ArevaEPRDCPEm Resource

From: WELLS Russell (AREVA) [Russell.Wells@areva.com]
Sent: Wednesday, May 18, 2011 3:13 PM
To: Tesfaye, Getachew
Cc: GUCWA Len (EXTERNAL AREVA); WILLIFORD Dennis (AREVA); BENNETT Kathy (AREVA); DELANO Karen (AREVA); ROMINE Judy (AREVA); RYAN Tom (AREVA)
Subject: Response to U.S. EPR Design Certification Application RAI No. 221, FSAR Ch 6, Supplement 15
Attachments: RAI 221 Supplement 15 Response US EPR DC.pdf

**QUESTIONS for Containment and Ventilation Branch 1 (AP1000/EPR Projects)
(SPCV)**

Figure 7.2-23—High Containment Pressure

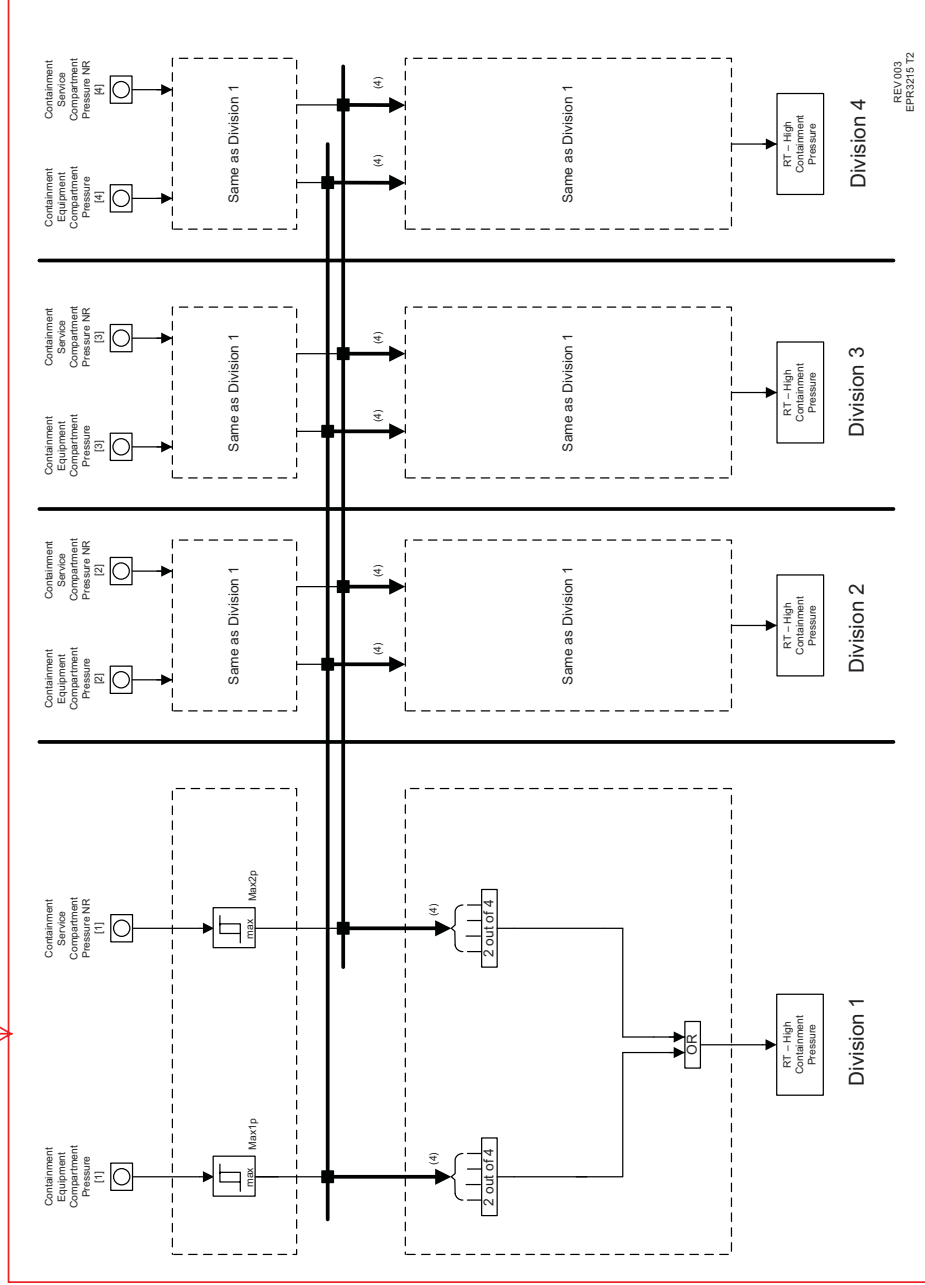
Provide technical specification surveillance requirements which will ensure that the foils and dampers of the CONVECT system and the safety-related doors in ANP-10299P perform their intended safety functions. The NRC staff requested that ITAACs be provided for these components in RAI 104:14-03.2.

06.02.01-24

06.02.01-24

Figure 7.3-30—Hydrogen Mixing Damper Opening.

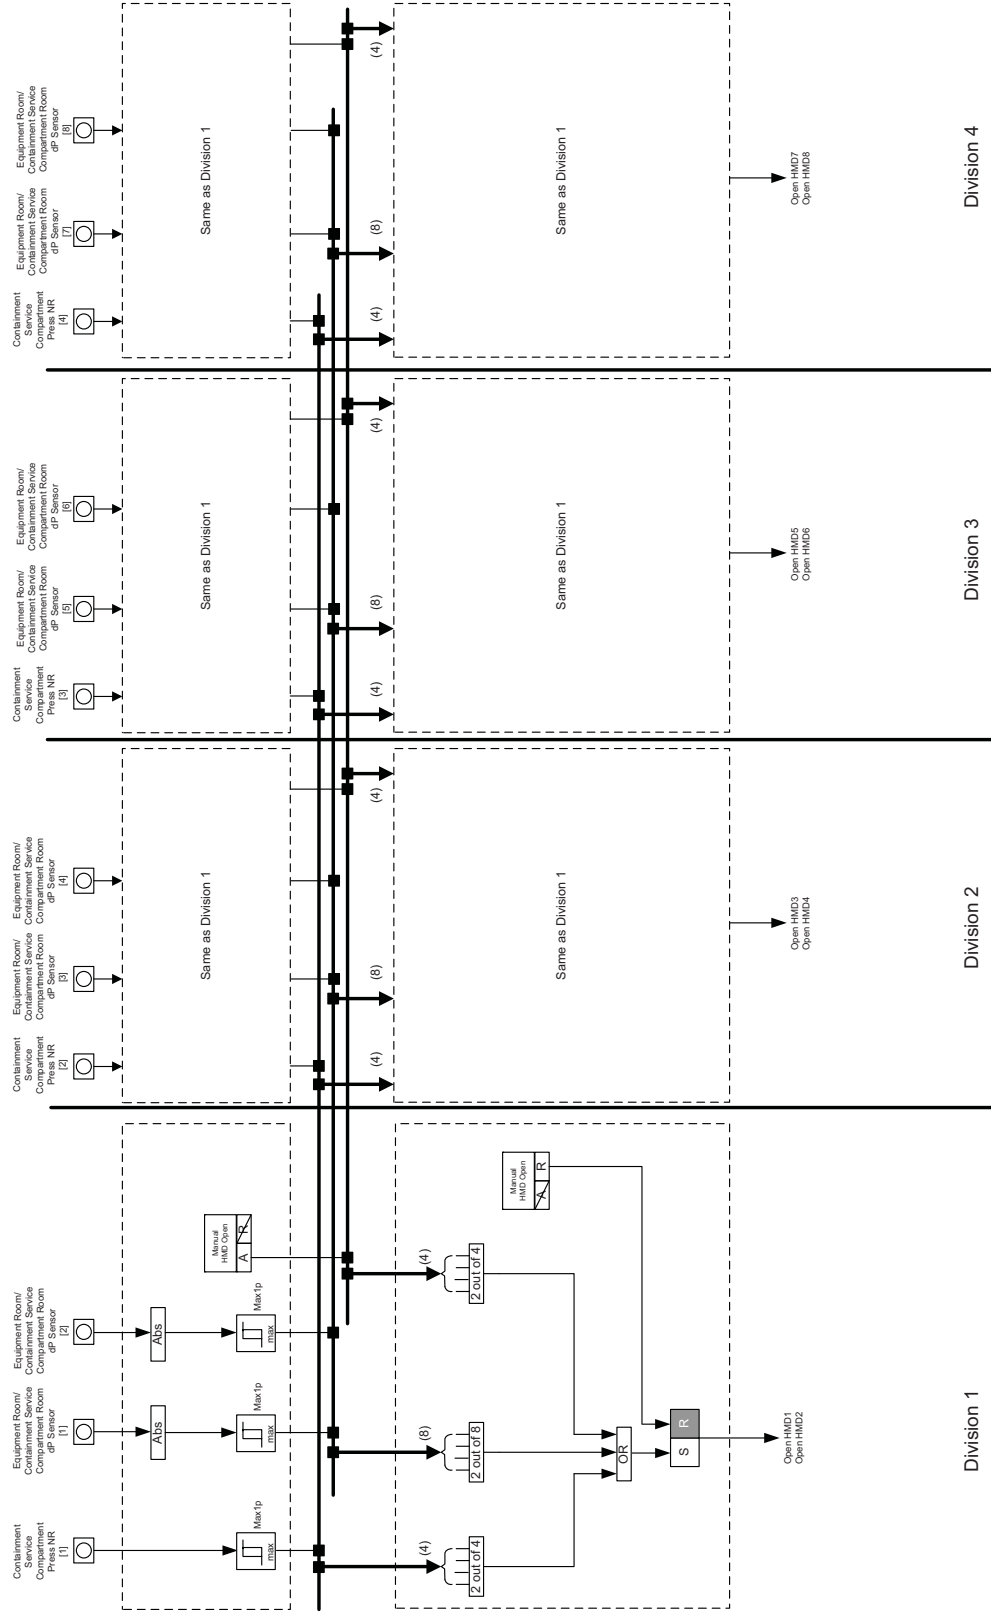
Question 06.02.01-16:

06.02.01-16 The combination of delta and absolute pressure sensors fulfills redundancy and diversity requirements. Upon loss of power, the HMDs open in a fail-safe position and remain open until power is restored. When power is restored, the HMDs will close automatically unless a high containment pressure condition exists. The plant operator can reset the instrumentation and controls (I&C) interlock function and manually operate the HMDs. Position sensors indicate the HMD position in the main control room. If an HMD opens unintentionally, it can be closed by either the actuator or the mechanical backup closing mechanism. In the unlikely case that a mixing damper remains open, the resulting leakage (cross-sectional area approximately 8 ft²), compared to the total leakage of penetrations and doors across the in-accessible and accessible rooms, is negligible. HMDs are installed in the accessible area which provides for maintenance access to the component during normal operation. Section 7.3 provides further detail about the I&C logic and logic diagrams of the HMDs.

Reset of the hydrogen mixing dampers opening sense and command outputs is available from the SICS in the MCR. A reset of the sense and command output does not result in a change of state of the actuators; it allows the operator to take further actions to manipulate individual components as may be necessary to follow plant operating procedures.

The functional logic for hydrogen mixing dampers opening is shown in Figure 7.3-30 - Hydrogen Mixing Dampers Opening.
